## PCI-SIG ENGINEERING CHANGE NOTICE

| <b>TITLE:</b>             | Platform Ref Clock PM Capability             |
| <b>AFFECTED DOCUMENT:</b> | PCI Express Base Specification Revision 1.0a |
| <b>SPONSOR:</b>           | David Harriman, Intel Corporation            |

**Figure 7-16: Link Capabilities Register**

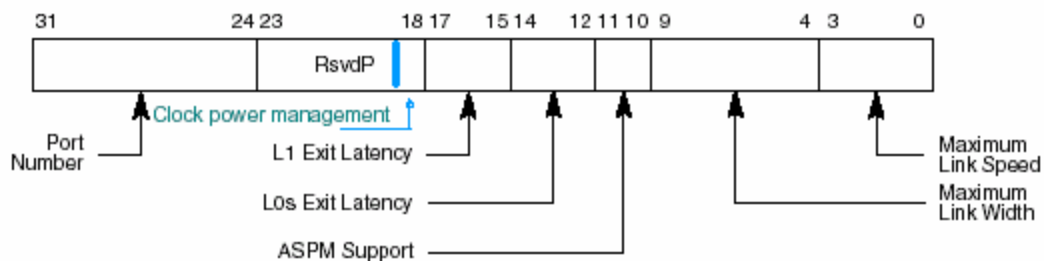
In Figure 7-16, label bit 18 (indicated) of the link capabilities register:

Figure 7-17: Link Control Register

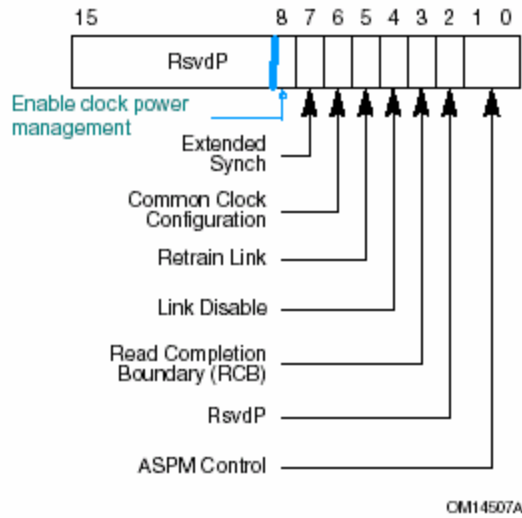
In Figure 7-17, label bit 8 (indicated) of the link control register:
